BID ADDENDUM NO. 1

Project Name: Raccoon Town
Owner: Port Gamble S'Klallam Tribe
Engineer of Record: Pat Fuhrer, P.E. – MAP Ltd

Addendum Date: April 2, 2026
Bid Due Date Unchanged: 12:00 pm April 15, 2026

C-10.05

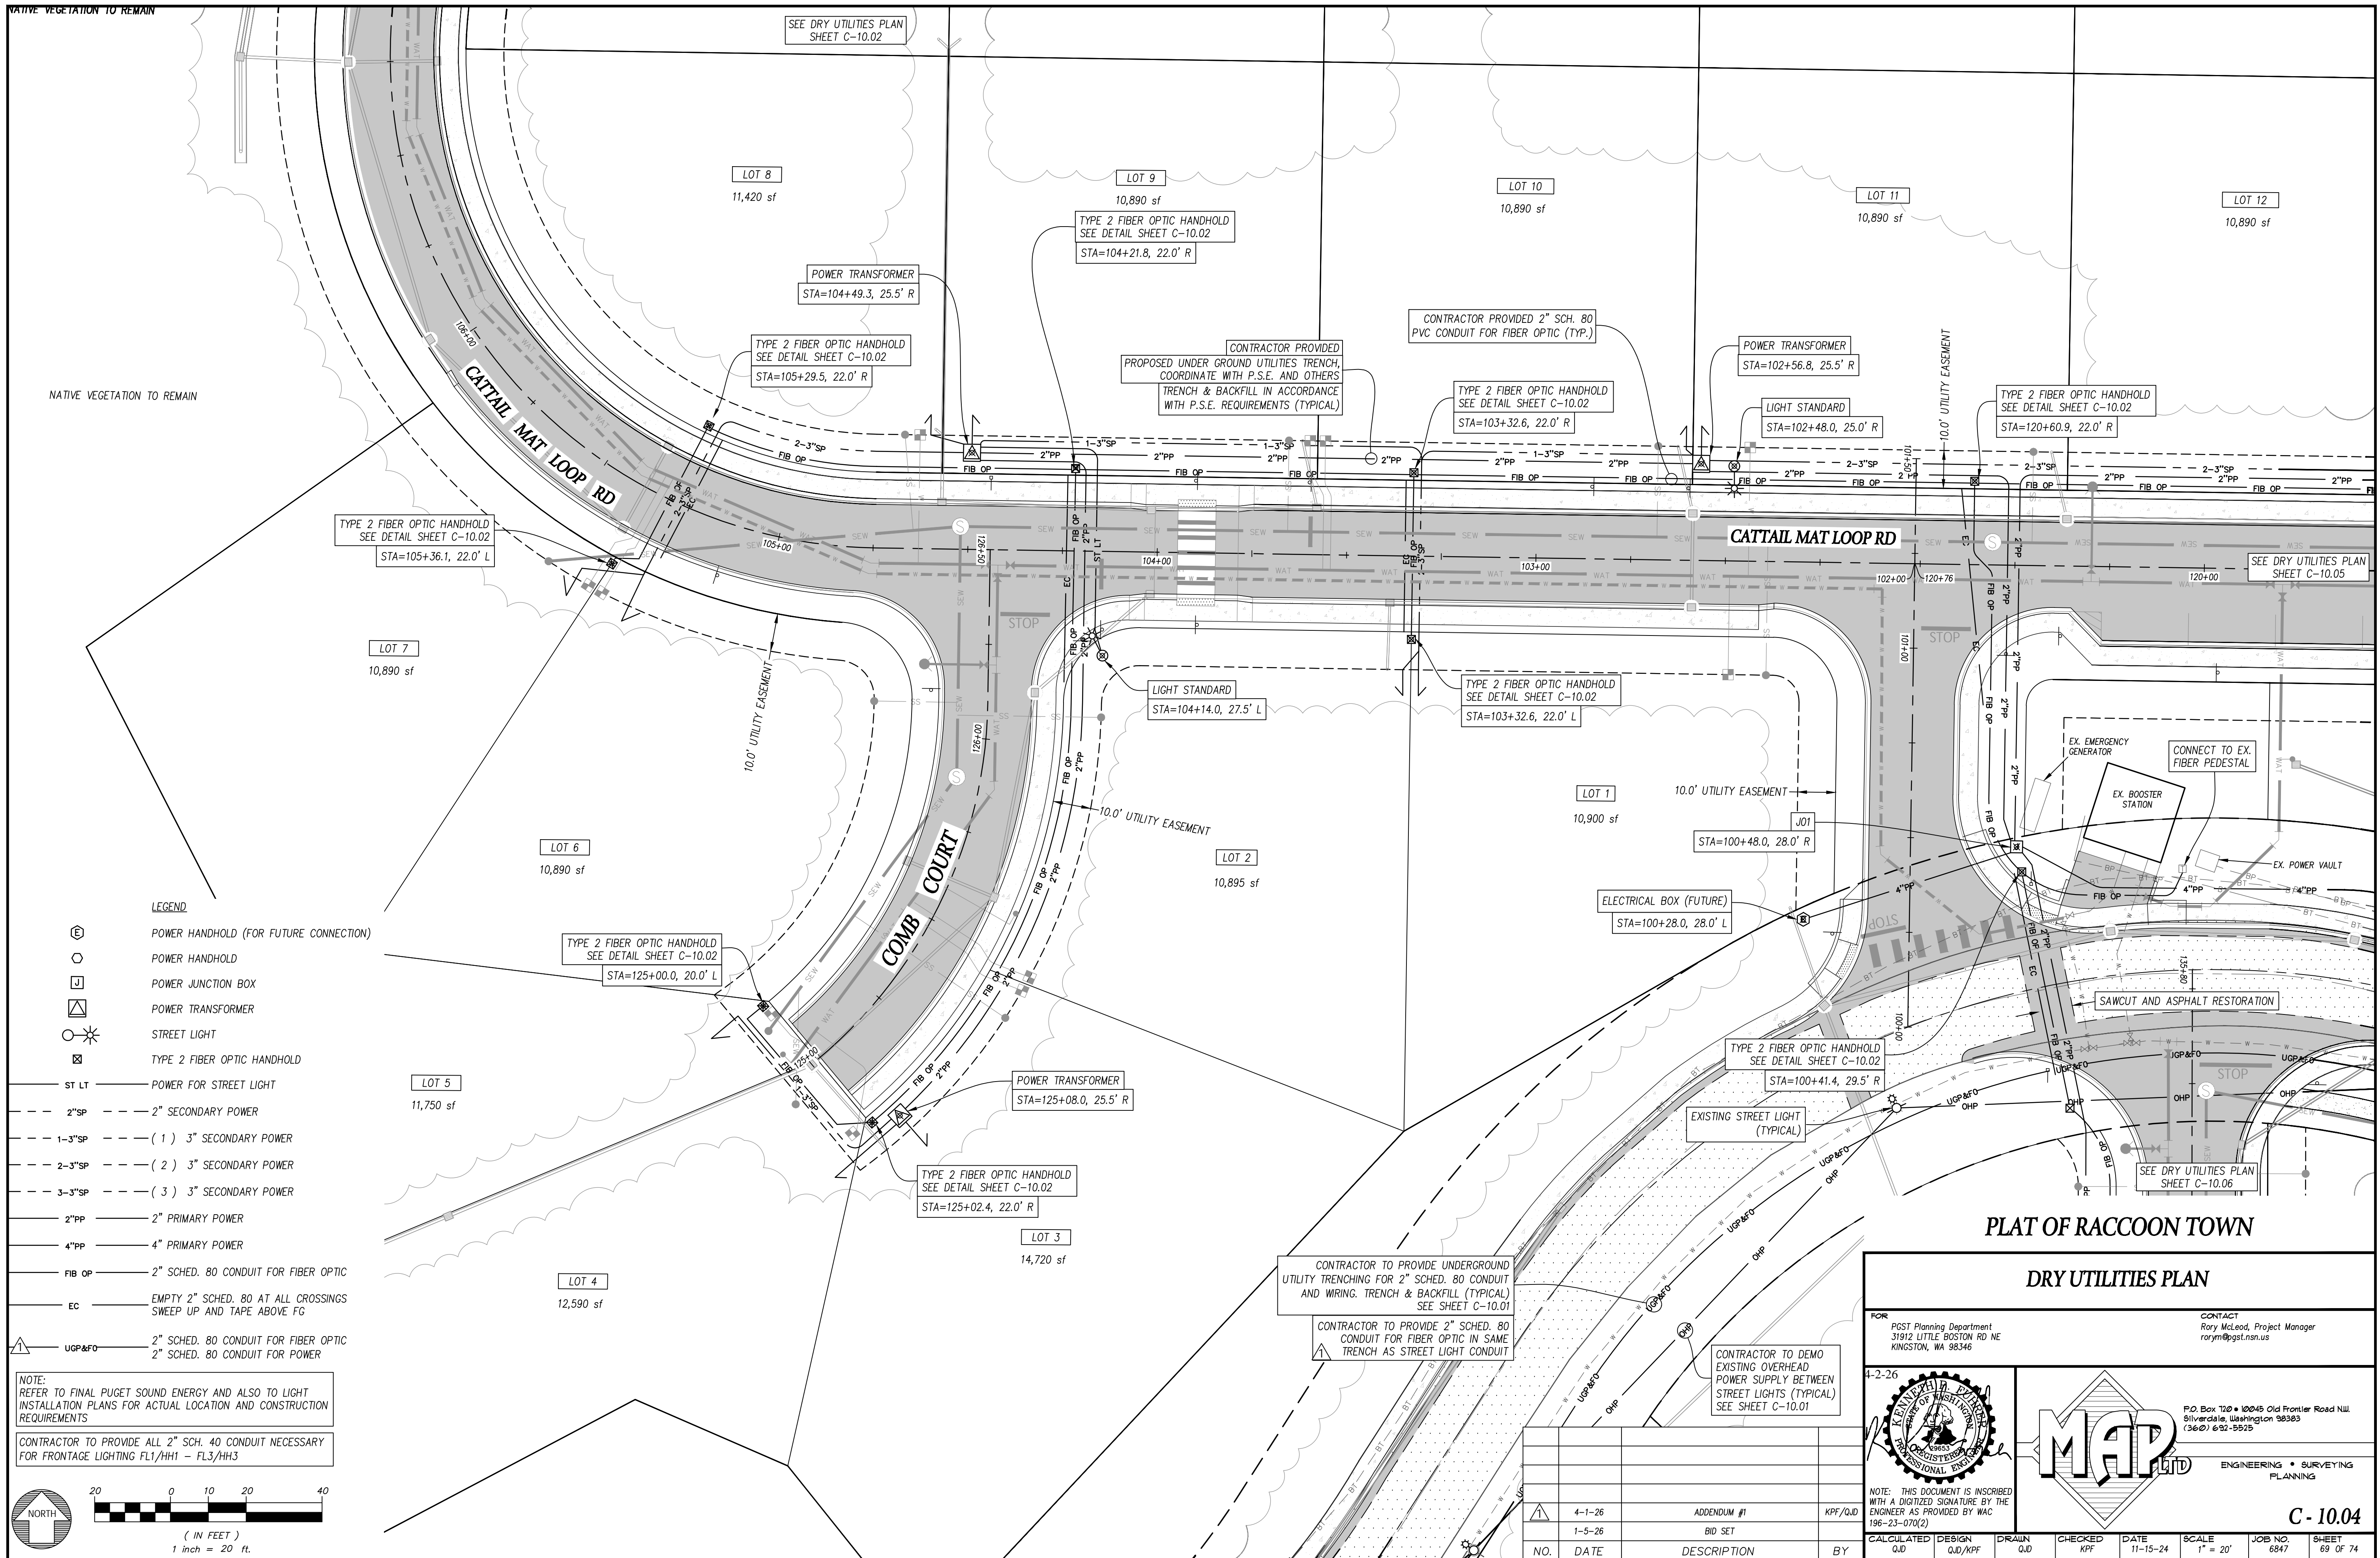
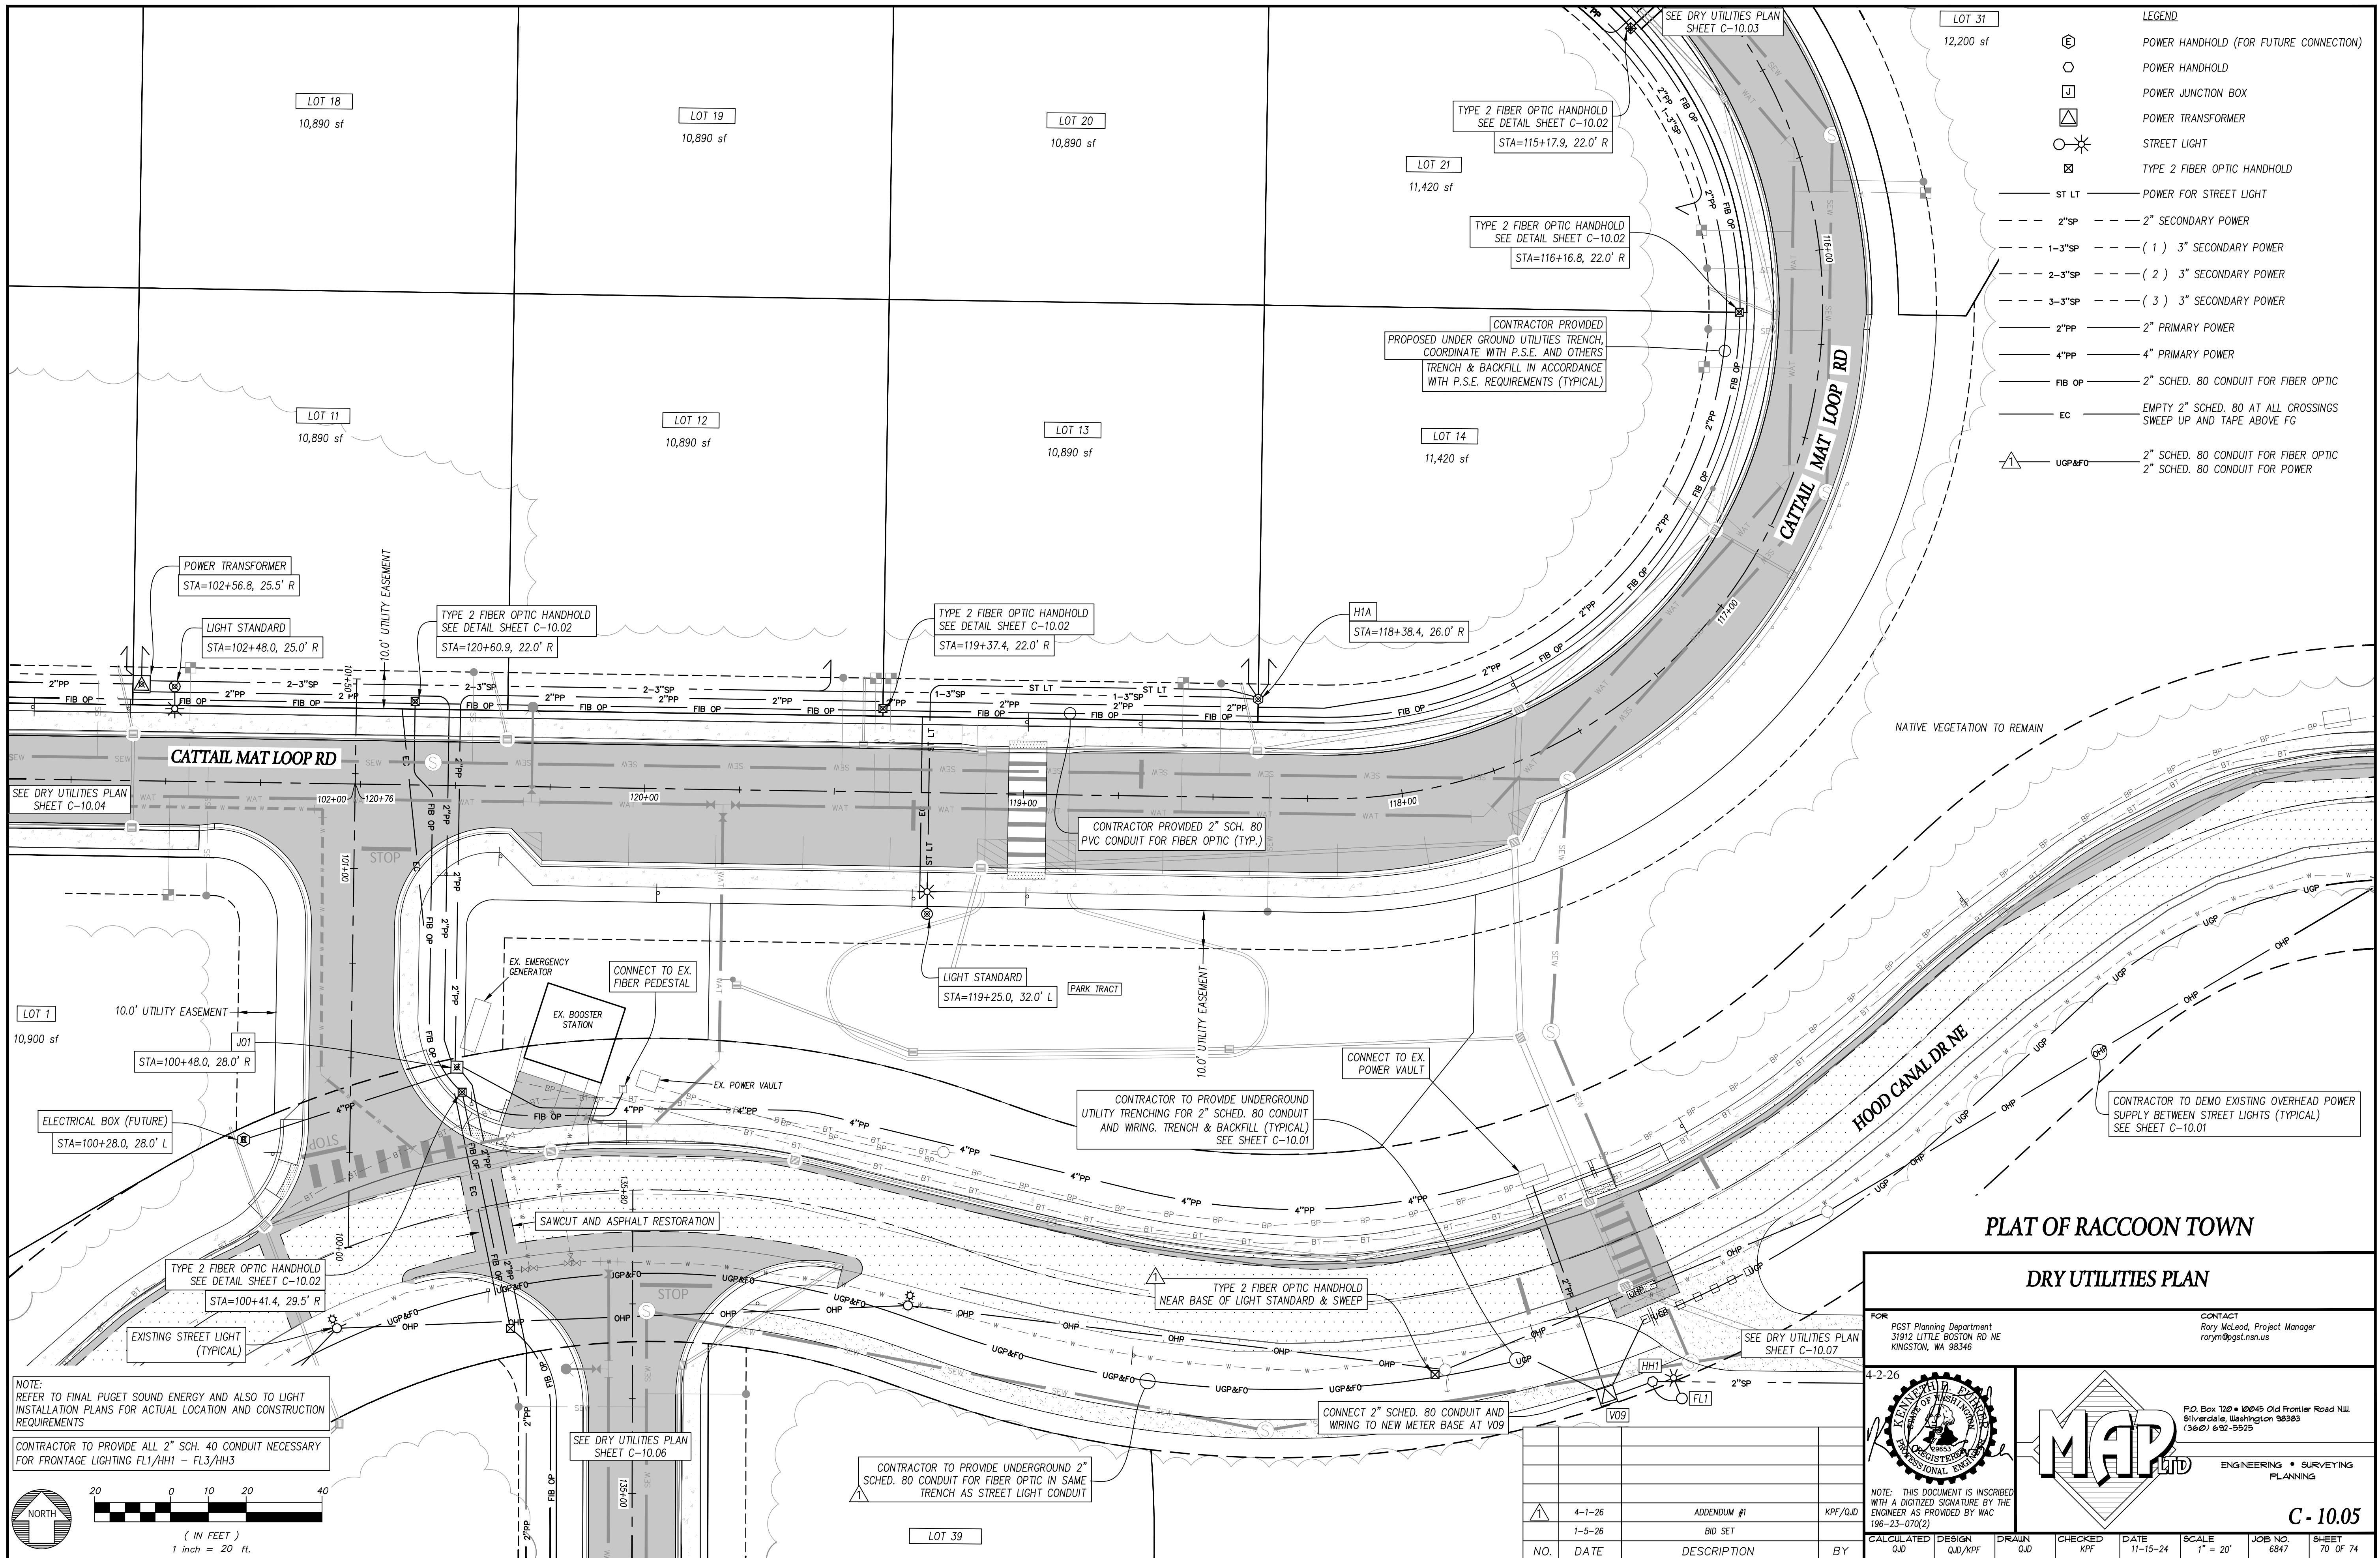
Please insert the attached revised plan sheets C-10.01, C-10.04, C-10.05, C-10.06, and C-10.07 dated 4-1-26 and sealed 4-2-26 into the bid set plans. These sheets were updated to include the Owner's request at the pre-construction meeting to **ADD** a second conduit and handholds to the street light trench for the Owner to install a fiber line. Also, a note was **ADDED** to clarify that the intent that the Contractor is responsible for re-energizing the Owner's street lights in Hood Canal Drive after undergrounding the conduit and pulling the new street light wire.

CONTRACTOR TO PROVIDE ALL 2" SCH. 40 CONDUIT NECESSARY
FOR FRONTAGE LIGHTING FL1/HH1 - FL3/HH3

CONTRACTOR TO PROVIDE UNDERGROUND 2" SCHED. 80 CONDUIT FOR FIBER OPTIC IN SAME TRENCH AS STREET LIGHT CONDUIT
